Subject: Vincentia Coastal Village - Mod 15 - Public Submission

Further to your letter dated 29 July 2016, please accept this email as a submission on the proposed Modification to MP 06_0060 and MP 06_0058 known as Mod 15. It would be appreciated if you could take the following comments into consideration in your assessment and provide additional information to ourselves where requested.

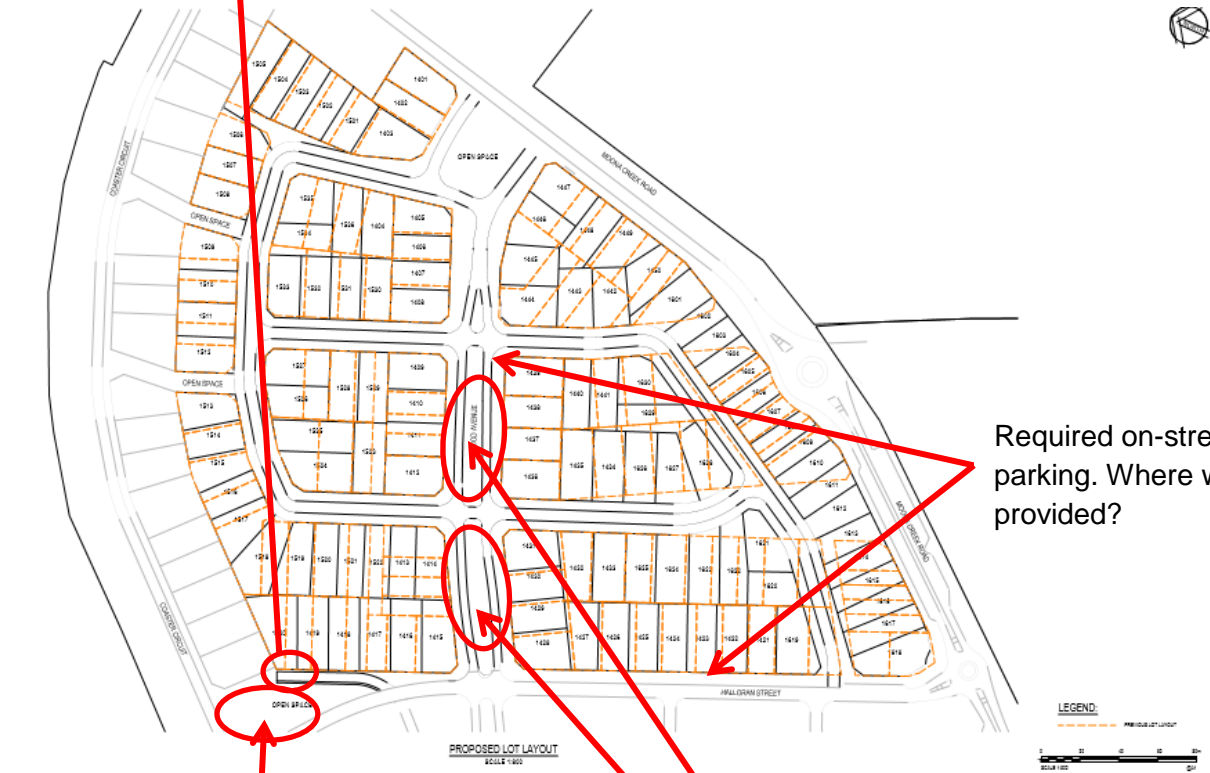
1. **Original Subdivision:** The overlay of the original subdivision plan appears to be inconsistent with the project approval MP06_0058 and MP 06_0060 subdivision layout. It is unclear from reviewing the information on the Department of Planning and Environment's (DoPE) web page when the submitted plan layout, noted as 'previous lot layout' was approved by DoPE (refer to plan with reference 82014047-11-SK04, Revision 1 – Proposed Lot Comparison Plan). It would be appreciated if the DoPE could advise when this layout was approved (i.e. approval number and/or modification number).

2. **Turning Area:** The laneway servicing proposed lots 1417 – 1420 has not been provided with any turning head to enable cars and service vehicles (e.g. a garbage truck) to enter, turn around and exit the laneway in a forward direction. This turning head when provided has the potential to have an adverse impact upon No.28 Coaster Circuit (existing lot 301) in terms of noise and vehicle lights if it is provided in close proximity of the western boundary of this lot. As detailed in Attachment 1 it is requested that this turning head when provided does not extend past the northern boundary of proposed lot 1420, should be positioned so it is located parallel to the western boundary of No. 28 Coaster Circuit (does not follow the front boundary alignment of proposed lots 1417 – 1420) and maintains a minimum separation of at least 3m to the south western corner/western boundary of No.28 Coaster Circuit. This separation enabling some landscaping/screening to be provided by the proponent. Refer red overlay in Attachment 1 for additional details. It is requested that prior to determination of Mod 15 details be provided on the proposed treatment at the end of laneway servicing lots 1417 – 1420 to minimise the impact on amenity (noise/visual/vehicular lighting) of No. 28 Coaster Circuit.

3. **Surface Levels:** There is insufficient detail in the submitted application to indicate what the finished surface levels of proposed lot 1420 and the laneway servicing lots 1417 – 1420, included required turning head, will be. This information is required to enable residents to assess and provide comment on amenity impacts (specifically the owners of No.28 and 30 Coaster Circuit – existing Lot 301 and 302). The land slopes to the north west in this section of the site with the land to the rear and west of 28 Coaster Circuit being at a higher level. Concern is raised that if the laneway and proposed lots are constructed at a higher level than the existing natural ground level then adverse impacts will be increased. While DoPE may consider that this will be provided as part of any future Construction Certificate application, adjoining residents need to have this level of detail know to be able to make an informed decision and provide accurate comments on the application.

4. **Open Space:** No details have been provided as part of this application on how the existing open space on the corner of Coaster Circuit and Halloran St is to be finished (i.e. left in its natural state or cleared).

It is noted that the current approval/Environmental Assessment (EA) details this area as natural/open space area (i.e. to be left treed). In this regard confirmation is sought that this area will be left in its natural state and will not be cleared. It is however noted that the current approval details that a 2.4m wide footpath will be provided along the eastern side of Halloran Street (adjacent to existing kerb) which will be provided as part of the development/Mod 15. It is requested that prior to determination details be provided on the proposed treatment of this open space to enable comment on the potential impact on amenity of No. 28 Coaster Circuit (noise/visual/vehicular lighting) to be provided.

5. **Bayswood Avenue:** It is noted that Council in their submission have raised concerns with the continuing of Bayswood Avenue as a twin roadway. Given that the current retirement village approval provided for open space areas and retention of trees around proposed dwellings, and given that it is now likely that the site will be cleared in its entirety, as has occurred with Stages 6, 7, 8 and 9, it is essential that where possible trees be retained within public areas to enable some integration of the existing natural environment into the development, for the benefit of fauna and the visual amenity of the area. The central vegetated area, as has occurred in Seagrass Avenue, has required the retention of existing established trees without the requisite for understorey landscaping to minimise burden on the Council (refer to Attachment 1). This continuing the theme that has been used within the development for ridge road construction and is as detailed in the approved EA. This in part outlining that it is the developments intention to integrate the natural environment into the development and reinforce coastal bushland as the dominant character of the site.

6. **Treatment:** No details have been provided on how the area adjoining the laneway servicing proposed lots 1417 - 1420 will be treated. Barriers have been provided in other areas within the development to prevent vehicle access. Bollards or a similar barrier should be provided along the western side of the laneway servicing lots 1417 – 1420 and at the end of the laneway to prevent parking in open space area and unauthorised vehicular access. This detail should be noted on the submitted plans or conditioned on any approval issued.

7. **Drainage:** No details have been provided with Mod 15 on how drainage for proposed lots 1420, 1505 to 1518 and the adjoining road system will be addressed. As the site drains to the north and north west it is envisaged that a drainage easement will be required within the above lots to ensure the new development does not adversely impact upon the existing lots fronting Coaster Circuit as a result of increased runoff. This detail should be noted on the submitted plans/or conditioned on any approval issued.

8. **Carparking:** The current approval requires the provision of additional car parking within the road reserve along the identified ridge roads (e.g. Bayswood Avenue) and connector roads (e.g. Halloran Street). The amended layout does not indicate where this car parking will be provided along the Bayswood Avenue extension. It is noted that on one of the submitted plans (Lot Dimension Plan) indicates what appears to be car parking, along Halloran Street. It is unclear as to how this car parking will work given the properties that front/gain access from Halloran Street (i.e. proposed Lots 1421 to 1428) will dramatically reduce the land available to provide this required car parking and whether sufficient car parking within the road reserve areas is able to be provided as specified by the Statement of Commitments (refer to Commitment No.66). The subdivision plan should clearly show the location of this required parking within the road reserve (i.e. both Bayswood Avenue and the section of Halloran Street – south of Bayswood Avenue) given the small lot sizes and limited frontages.

9. **Level of Detail:** There is insufficient detail in the submitted information/supporting plan to indicate the following, which is required by residents to determine the full impact of the proposal on the amenity of their adjoining properties:

- a) Updated details on vehicular turning area for car and service vehicles (i.e. garbage trucks) at the end of the laneway servicing Lots 1417 – 1420 Halloran Street to enable assessment of impact on amenity of 28 Coaster Circuit;

- b) Finished surface levels of sites and laneway servicing lots 1417 – 1420 to enable assessment of impact on amenity of 28 and 30 Coaster Circuit;
- c) Details on the setback of proposed laneway servicing lots 1417 – 1420 from western boundary of No 28 Coaster Circuit;

- d) Proposed treatment at the end of laneway servicing lots 1417 – 1420 to minimise impact on amenity (Noise/Visual/Offensive vehicular lighting) of No. 28 Coaster Circuit.

- e) Details on how the open space on the corner of Coaster Circuit and Halloran St is to be finished (i.e. left in its natural state or cleared);
- f) Details on what measures will be installed around the laneway servicing lots 1417 – 1420 (i.e. bollards or similar barrier) to prevent parking on/within this area; and

- g) Details on how drainage for the proposed northern lots will be addressed so as to ensure there will be no impacts from increased overland stormwater flow.

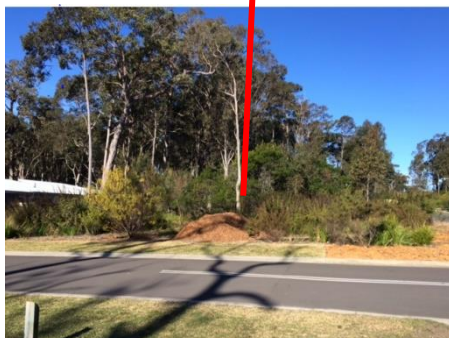
Turning head is required with end of street repositioned so it runs in line with existing property boundaries.

Required on-street car parking. Where will it be provided?

Existing treed open space area should remain.

Existing trees should be retained within Bayswood Avenue extension.
